ADDENDUM NO. 2

Reference: UVU Student Life Center & Parking Structure
Orem, Utah
DFCM Project No. 10289790

STUDENT LIFE CENTER & PARKING STRUCTURE

The original specifications and drawings, dated April 27, 2012 for the project referenced above are amended in this Addendum No. 2, dated May 04, 2012.

A1 / SF-102a FLOOR & LOW ROOF FRAMING PLAN - LEVEL 2 ZONE A

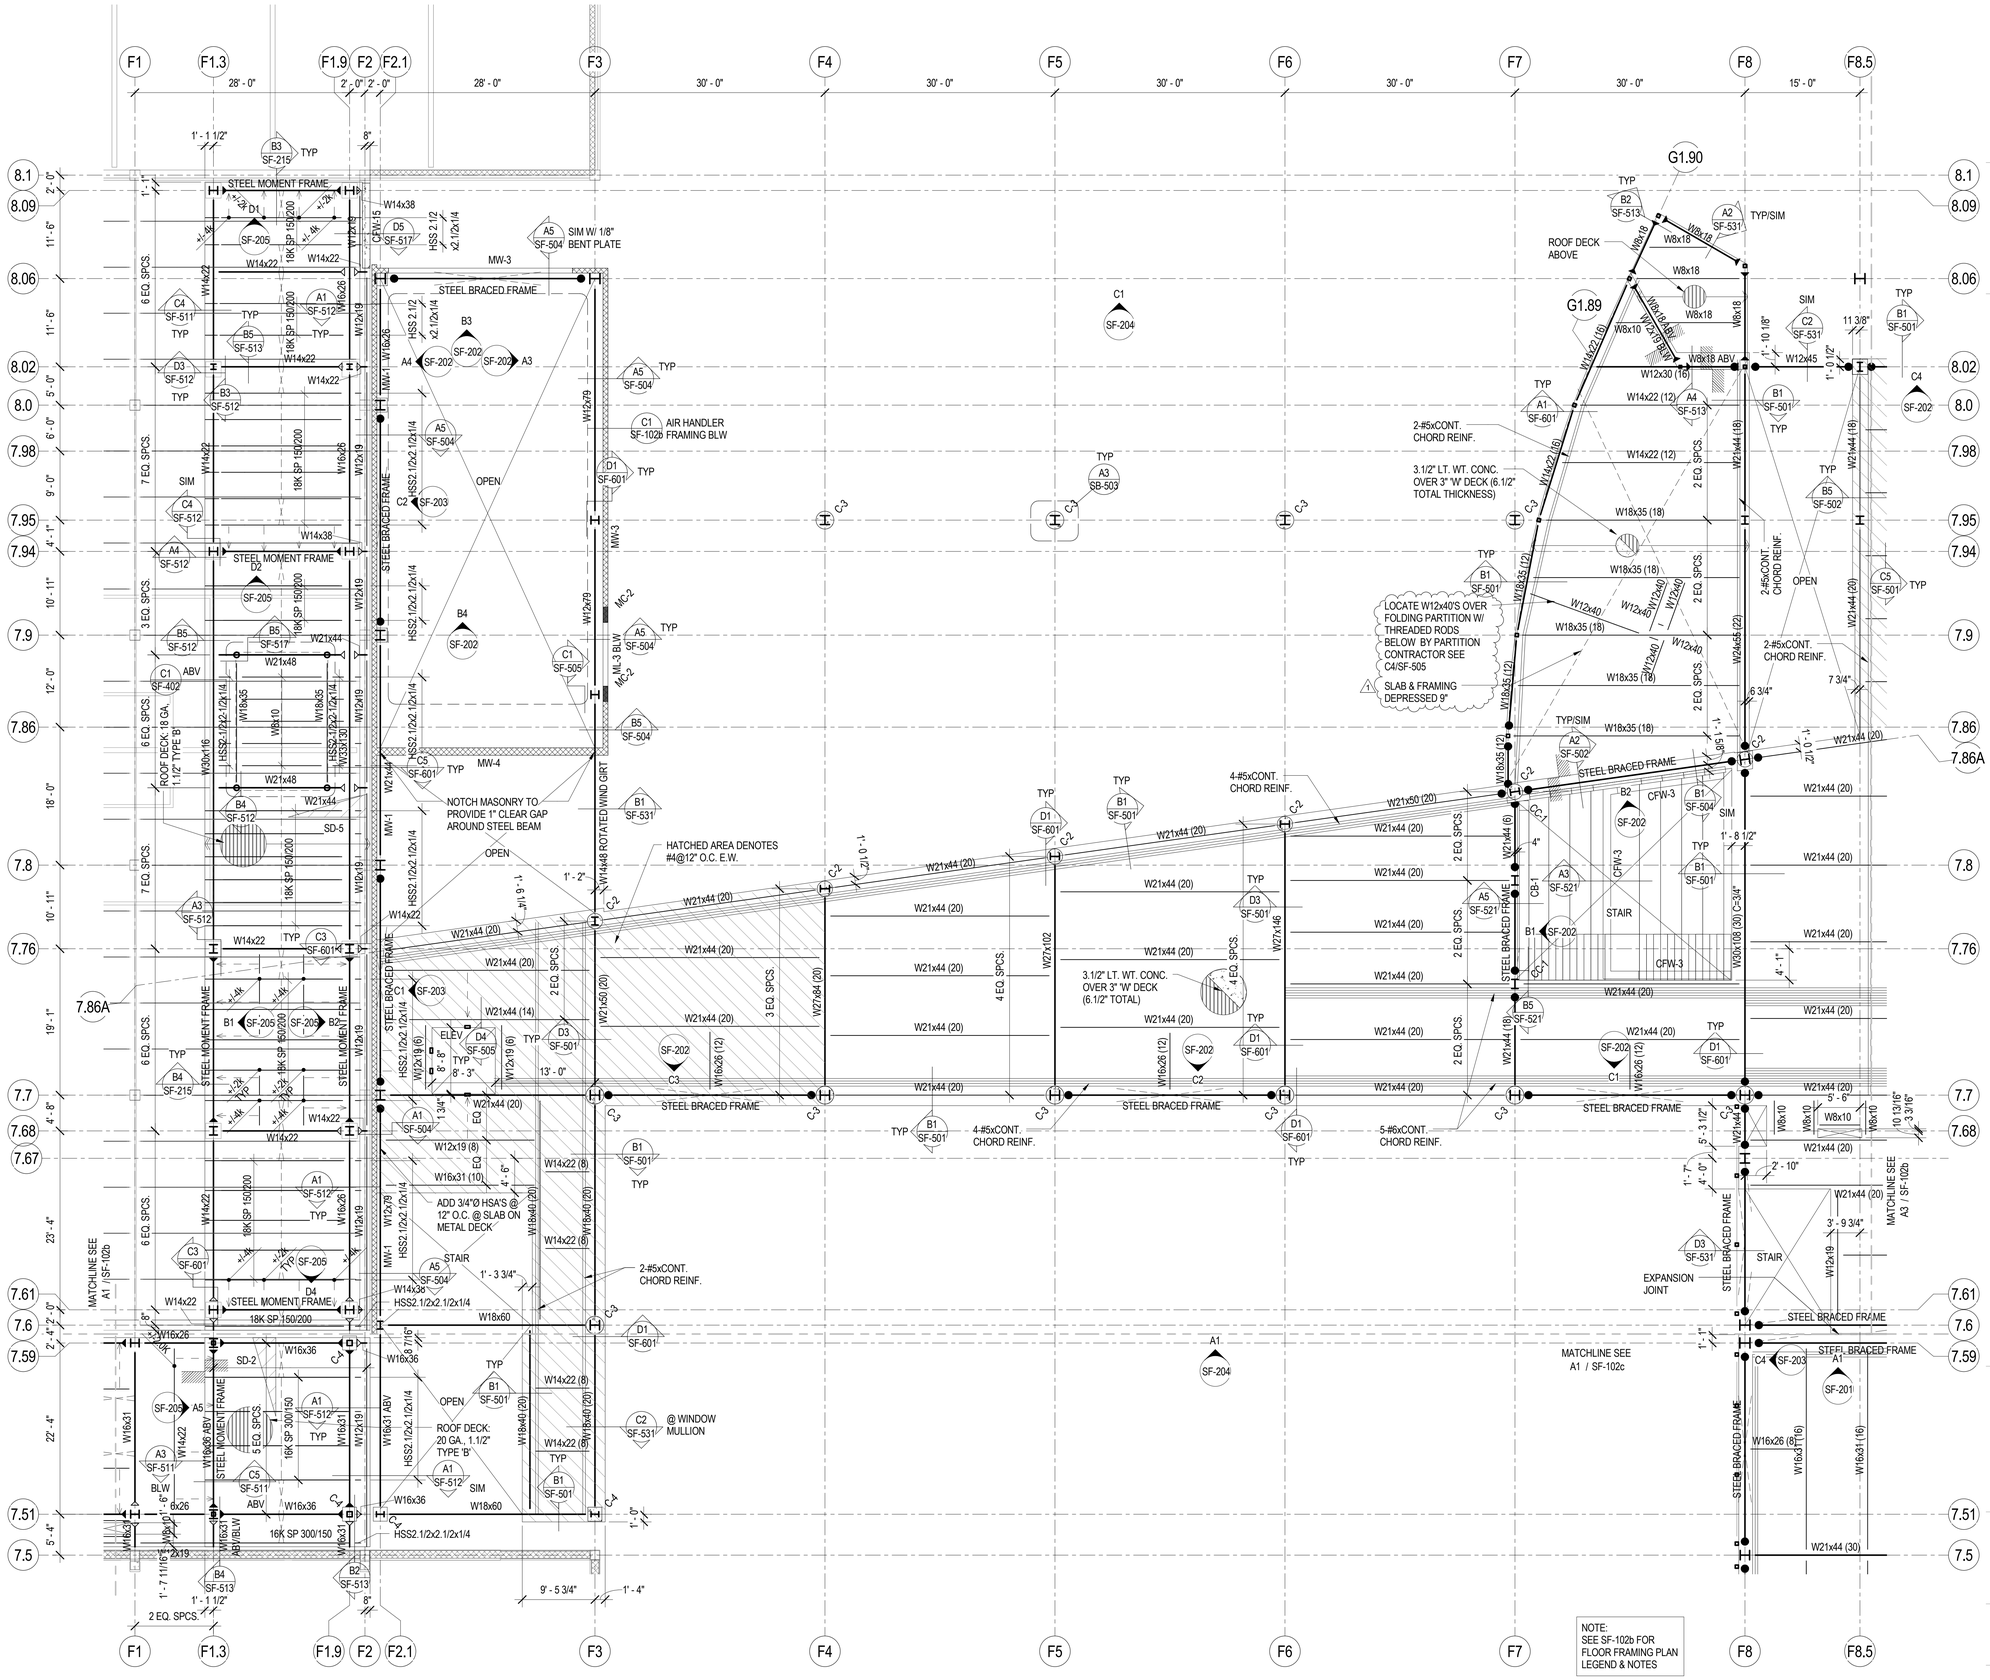
Sheets SF-102a:
1. See revised partial second floor and low roof framing plan area A.

A3 SF-102b FLOOR FRAMING PLAN - LEVEL 2 ZONE B

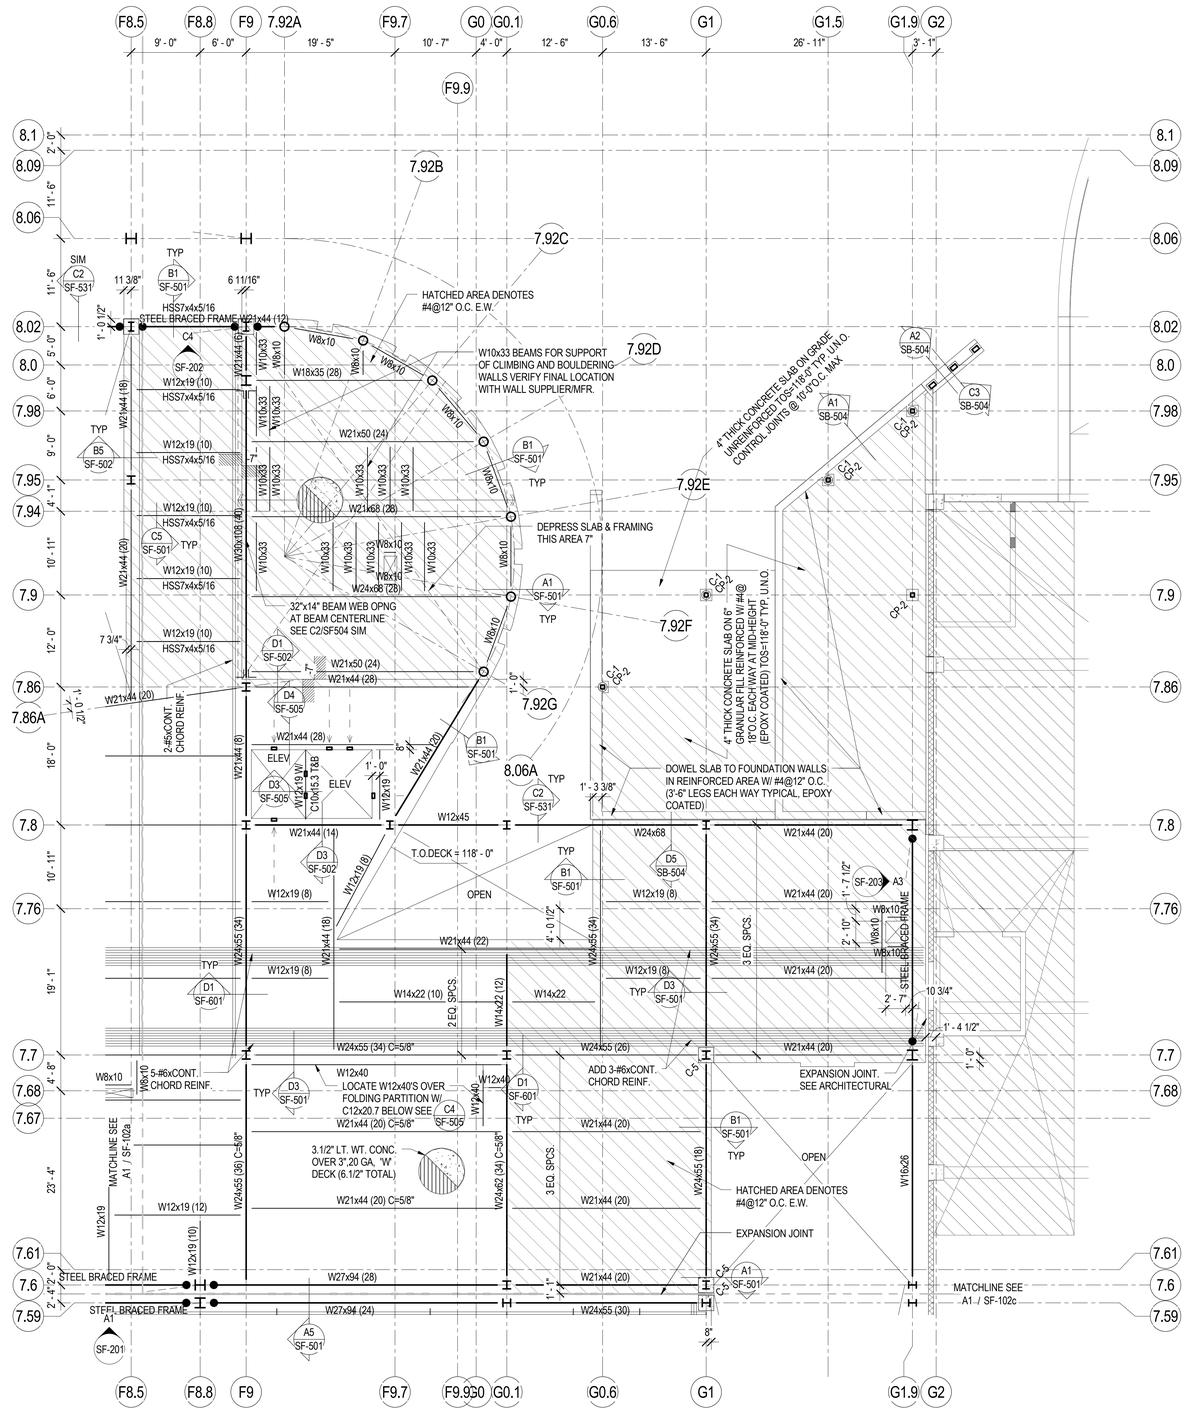
Sheets SF-102b:
1. See revised partial second floor and low roof framing plan area B.

A1 SF-102c FLOOR FRAMING PLAN - LEVEL 2 ZONE C

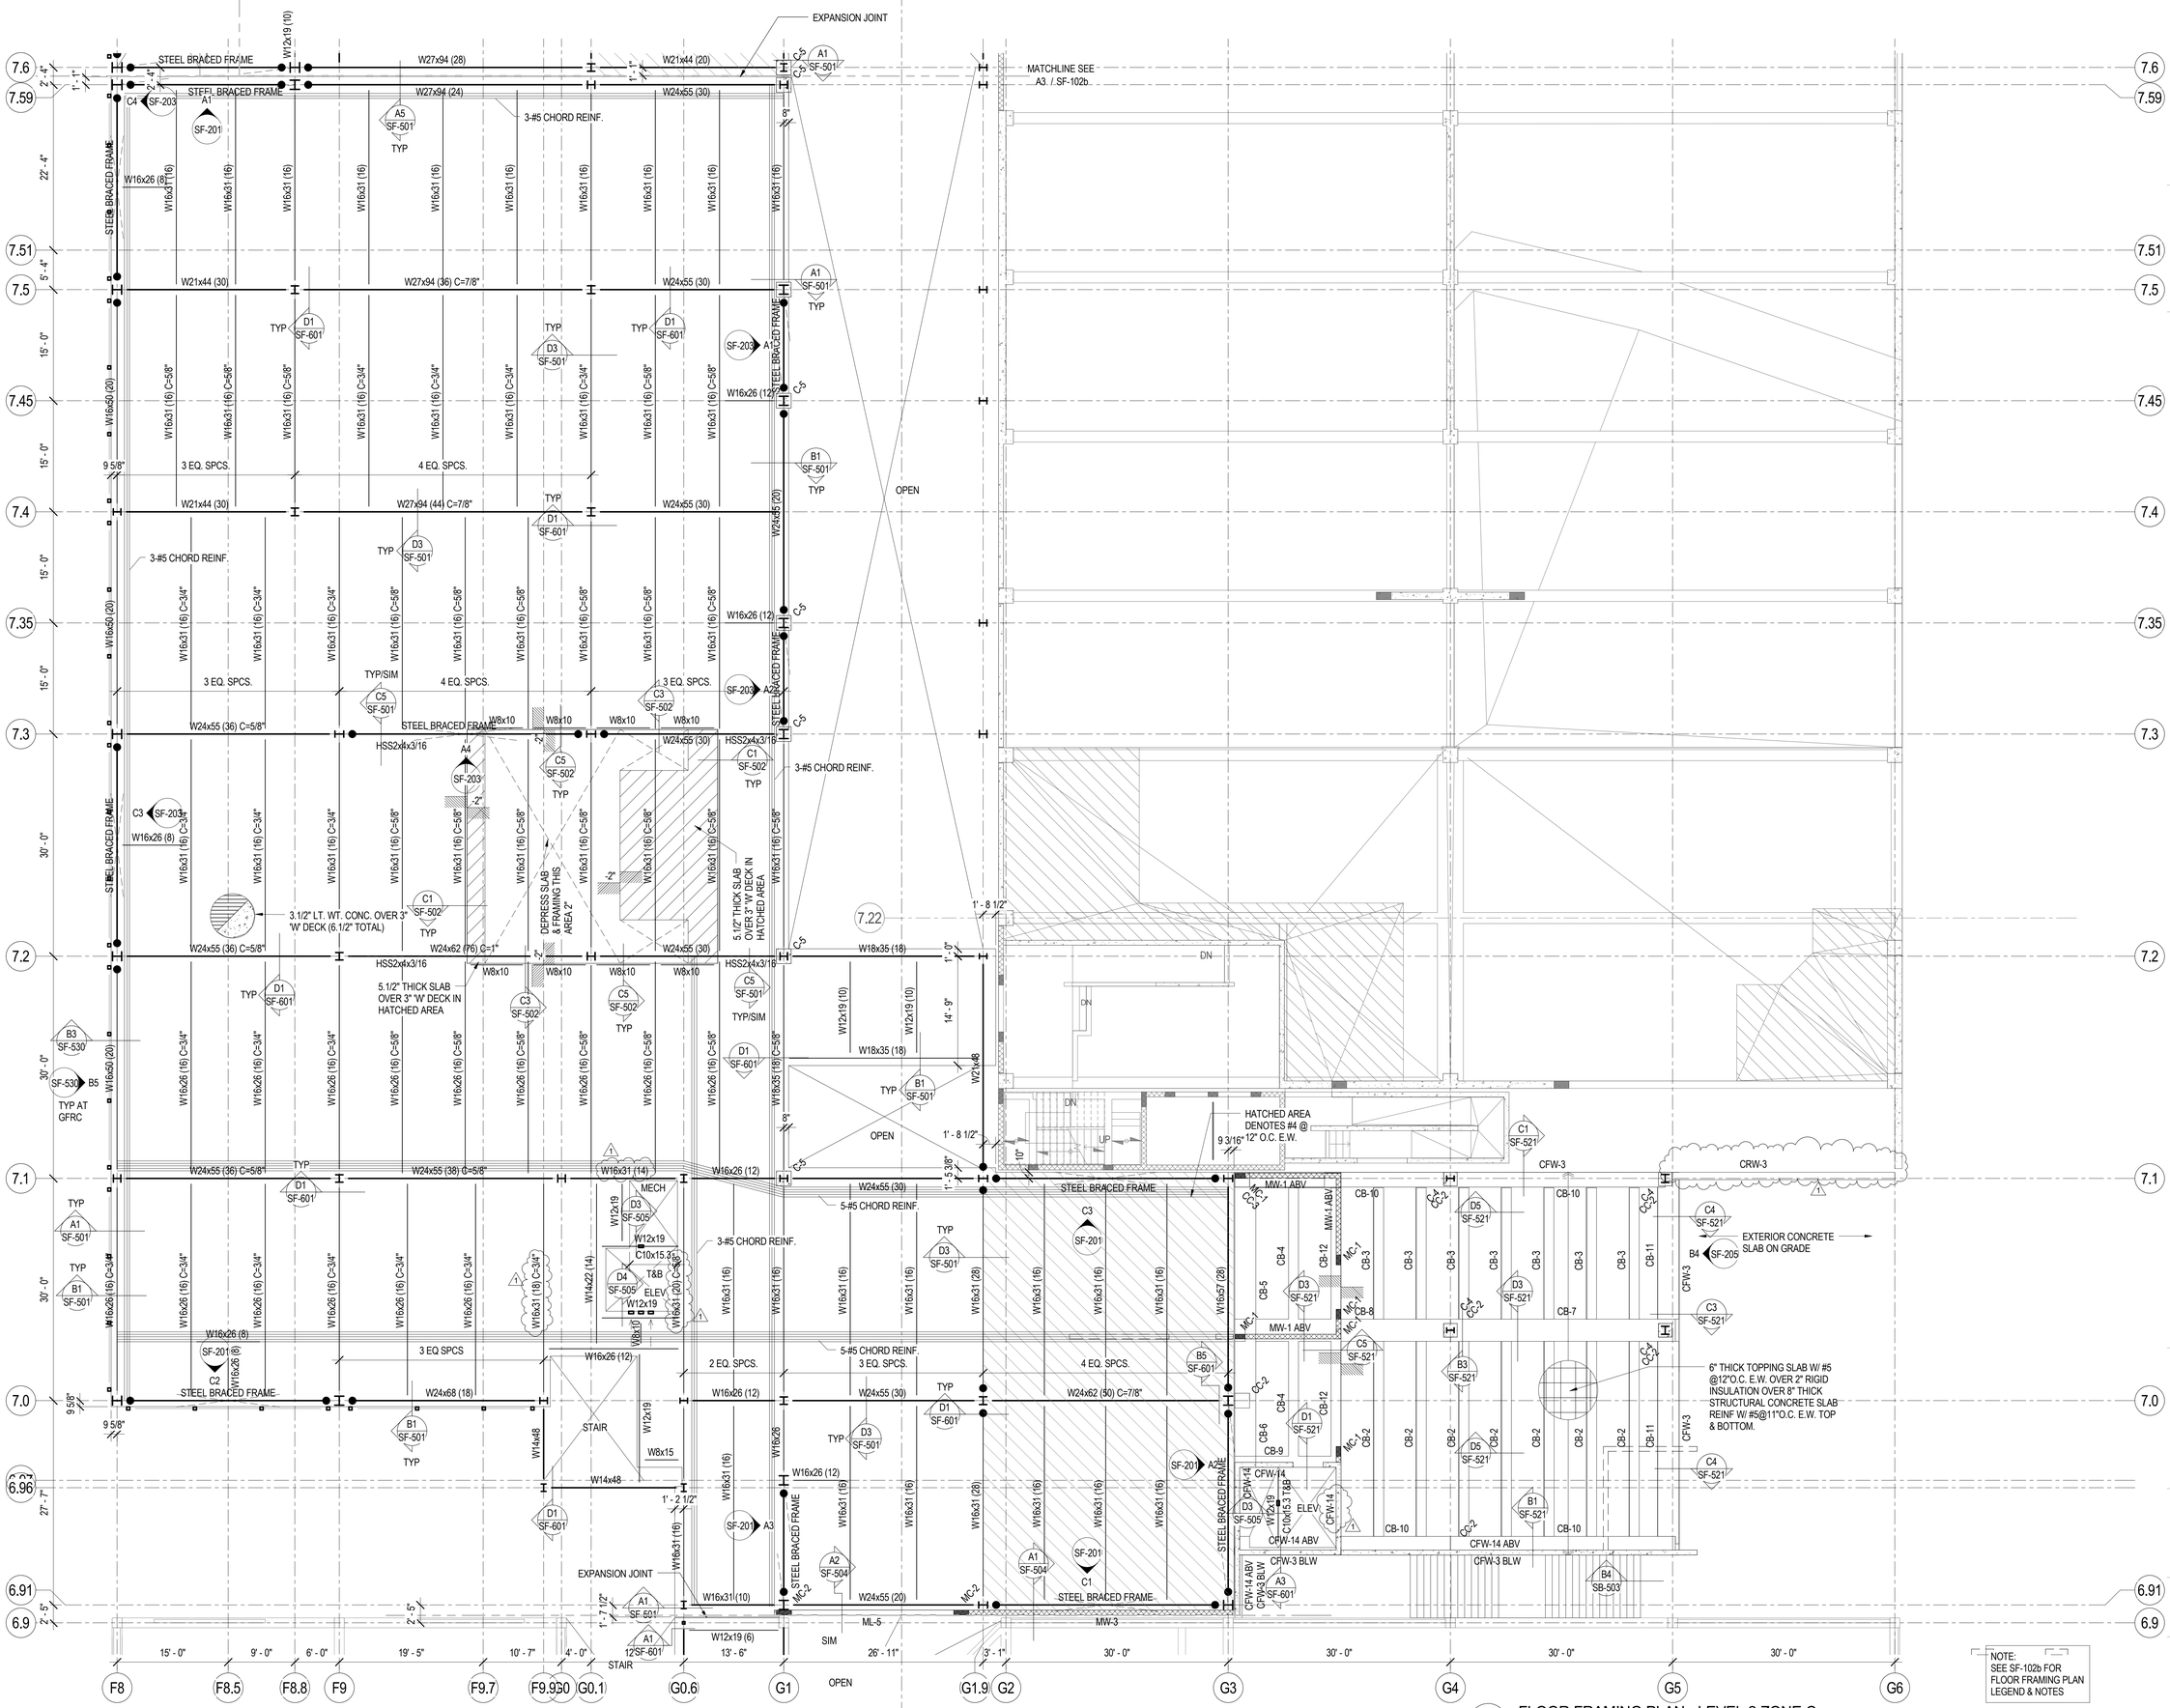
Sheets SF-102c:
1. See revised partial second floor and low roof framing plan area C.
